**PLANNING COMMISSION SITE PLAN
RESIDENTIAL INFILL DEVELOPMENT PLAN REVIEW SHEET**

CASE NUMBER: SPC-2016-0028A **PLNNG. COMM. DATE:** 12-13-2016

PROJECT NAME: Latitude Webberville

CITY OF AUSTIN – DEVELOPMENT SERVICES DEPARTMENT
SITE PLAN APPLICATION – MASTER COMMENT REPORT

SHEET
CS101
3 OF 3
SPC-2016-0028A

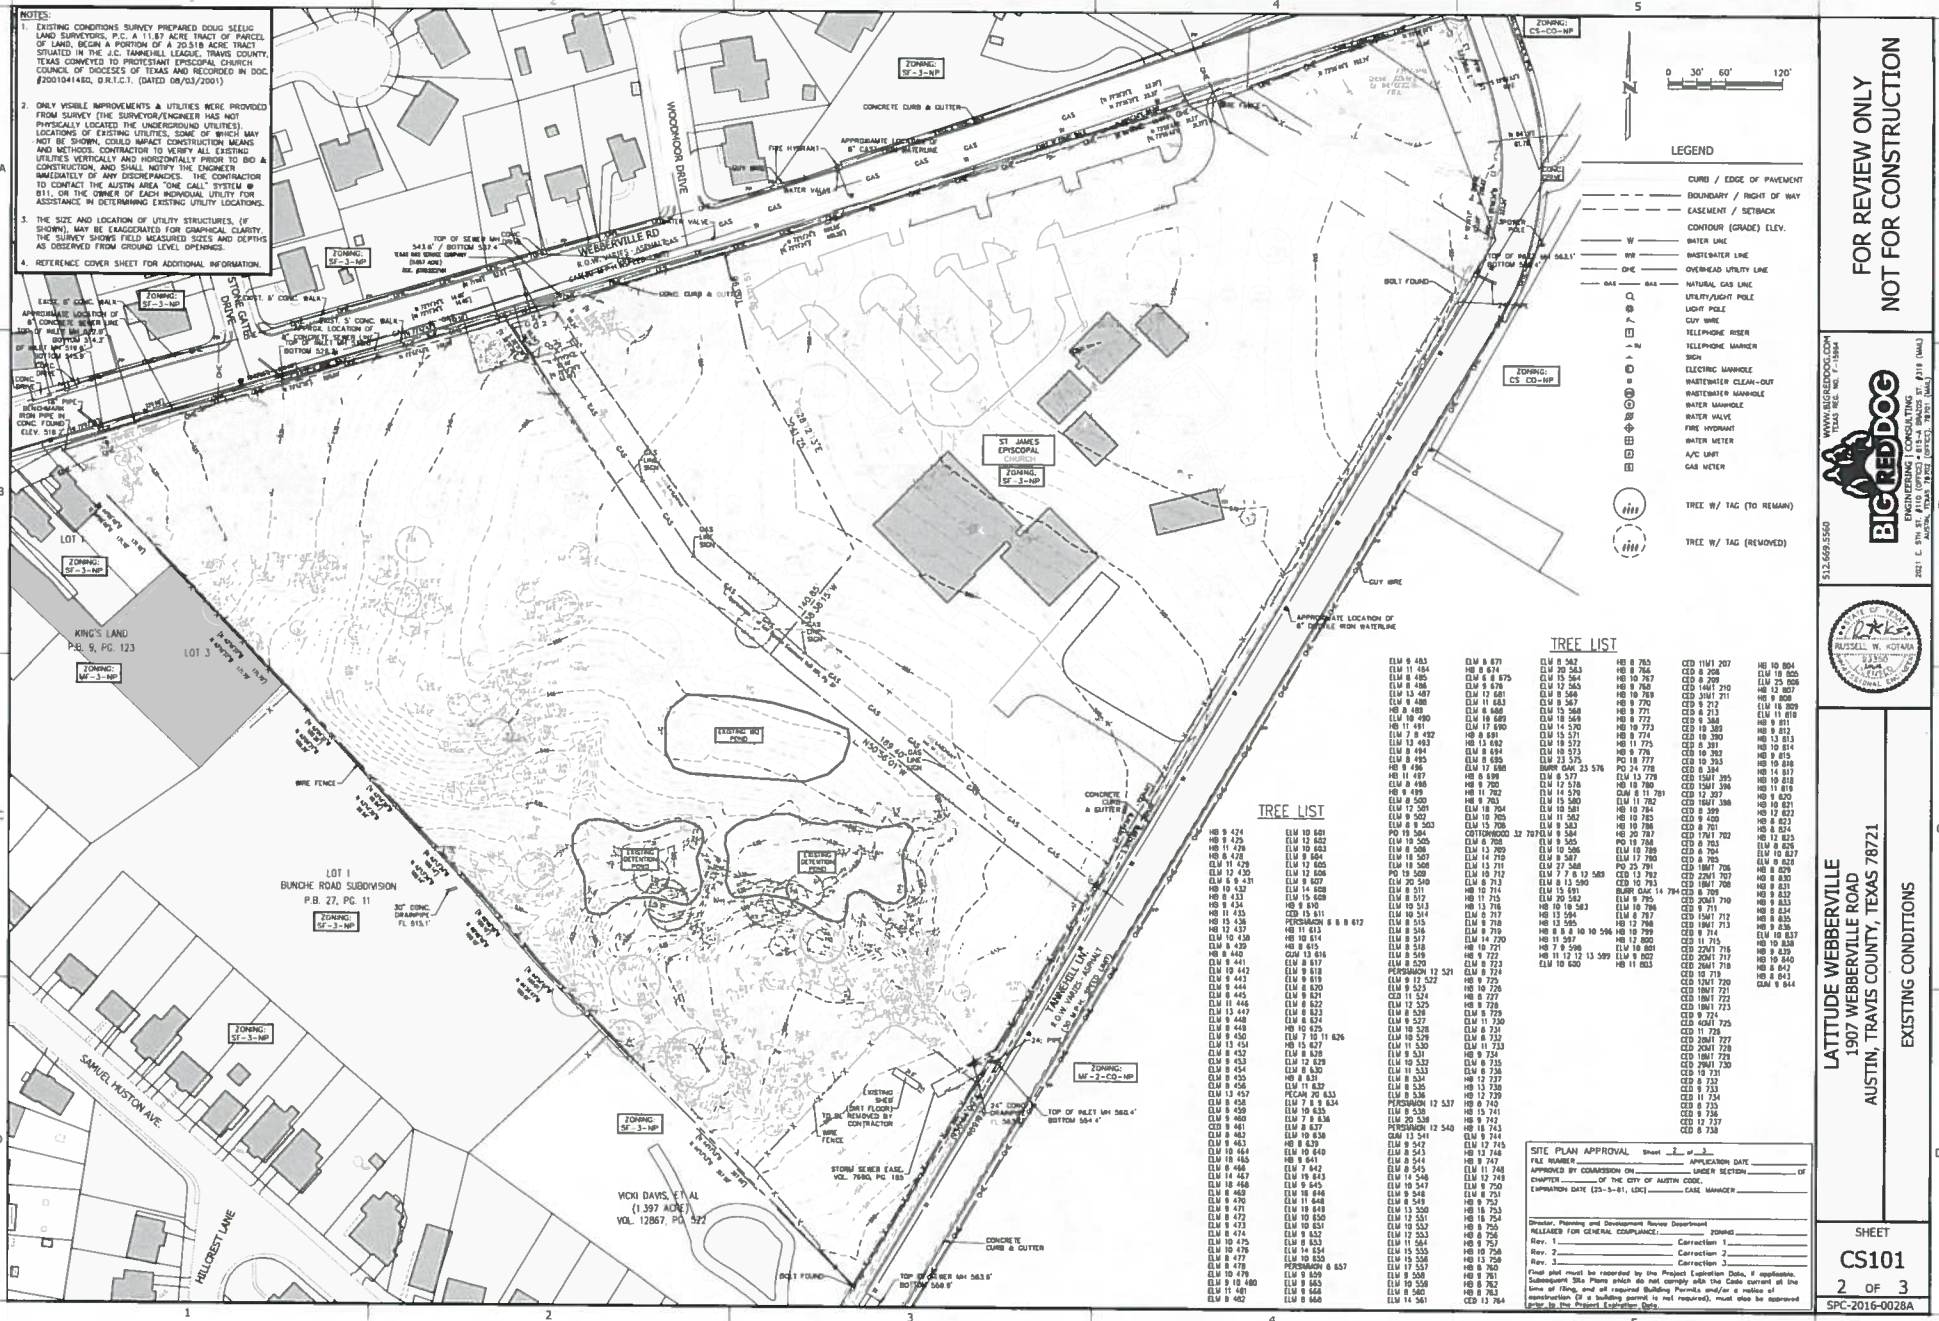
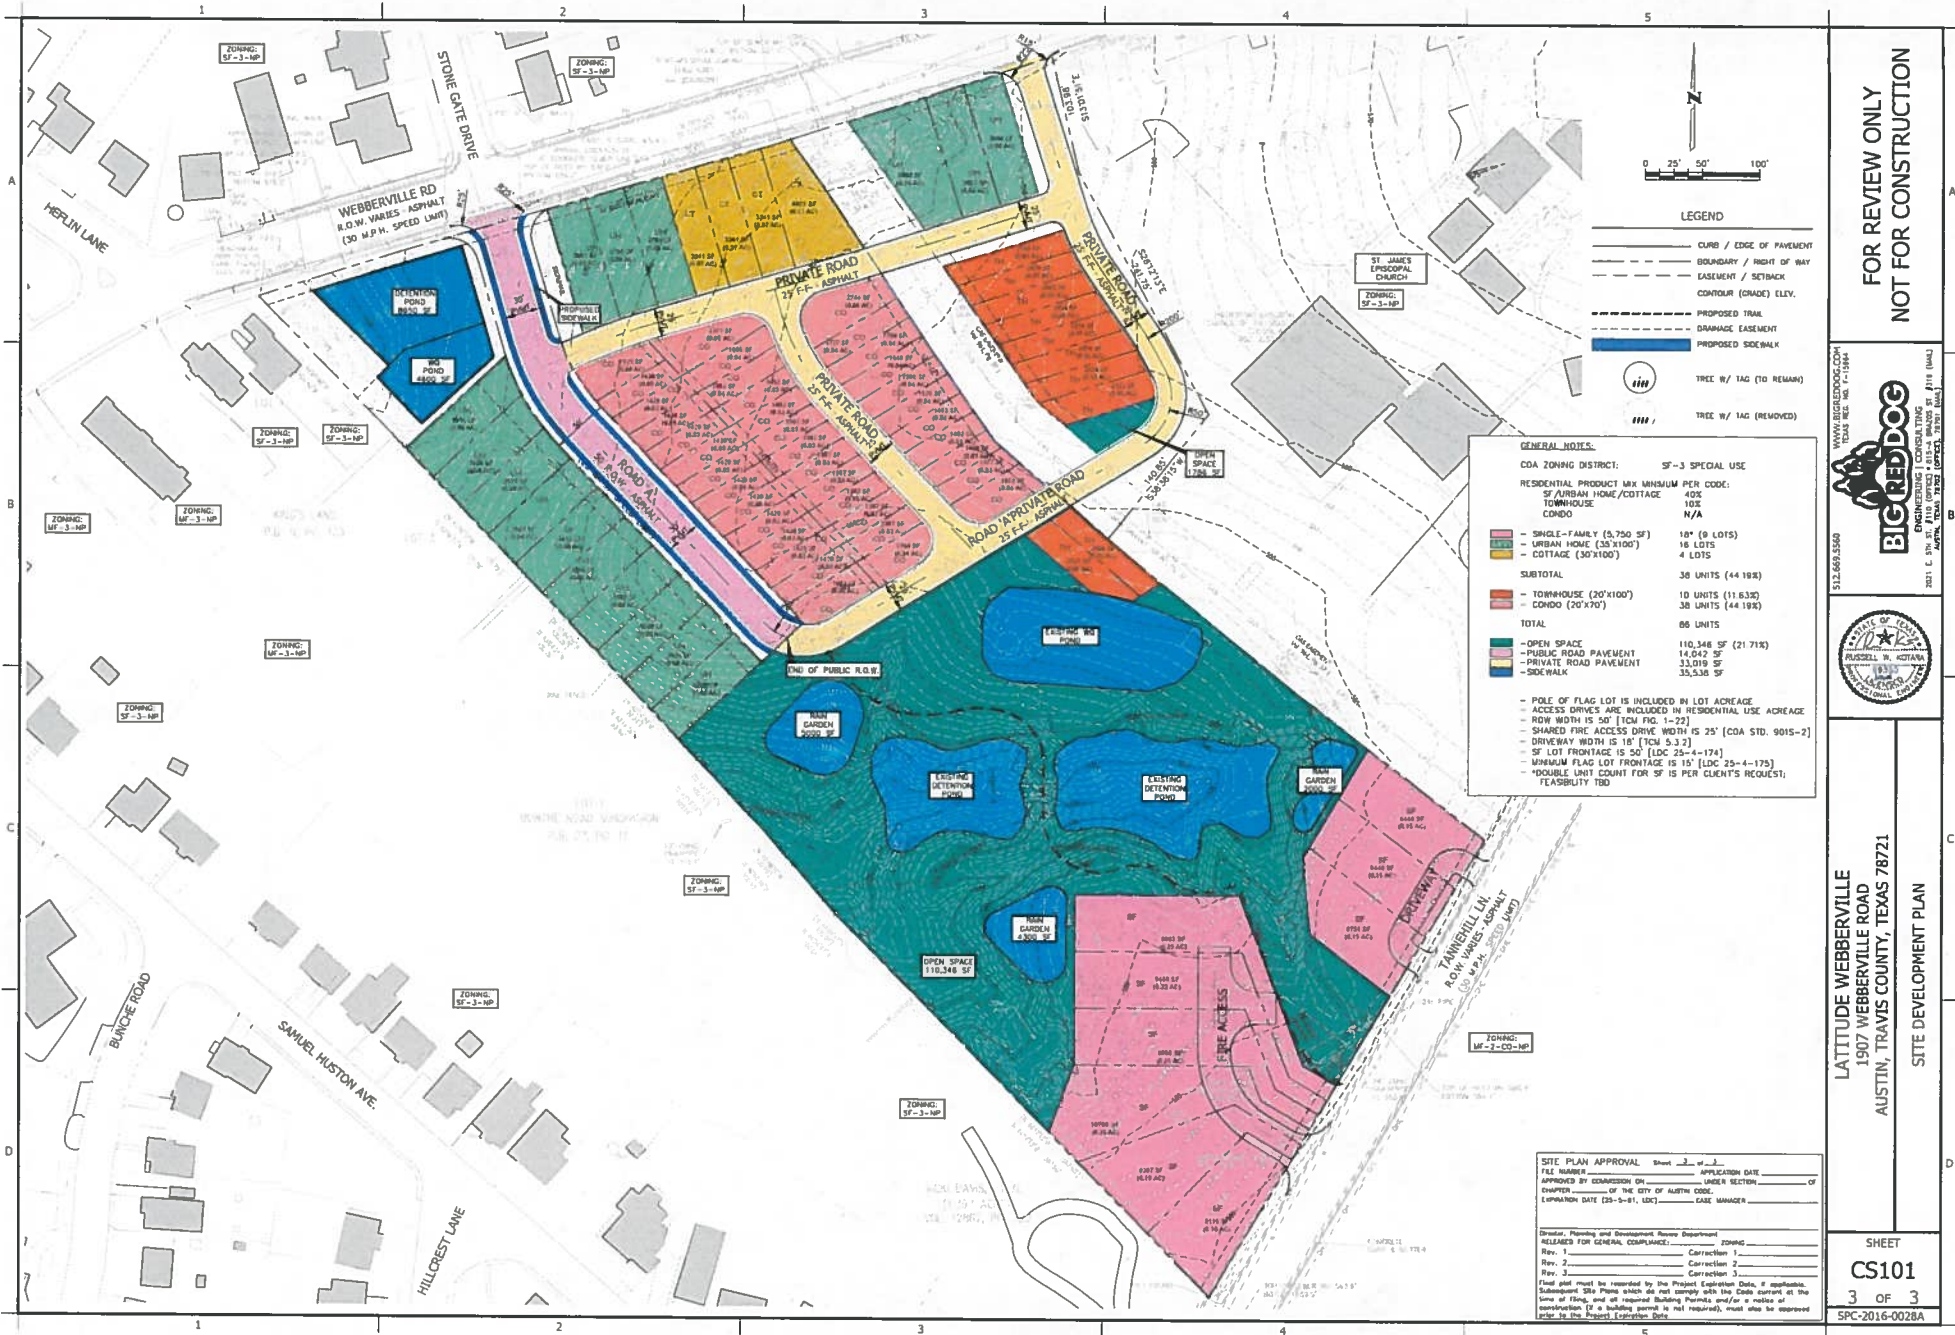
Staff comment: There is an existing Capital Metro bus stop on the Webberville Road side of this project. Access from the Tannehill Road side of the project is proposed via a pedestrian/ bike trail that connects the sides. This would be a ¼ mile walk/ bike connection that did not previously exist.

Staff comment: The maximum height proposed on any unit in this project is 35'. Any proposed uses that are denser than standards single family homes are in compliance with compatibility standards when adjacent to single family zoning or use.

Staff comment: The central portion of this site is a large open space feature which will be imminently accessible to all residents of this proposed project, and to the public in general. The open space will have trails, seating, tables, ponds and landscaping. It will function like a small neighborhood park.
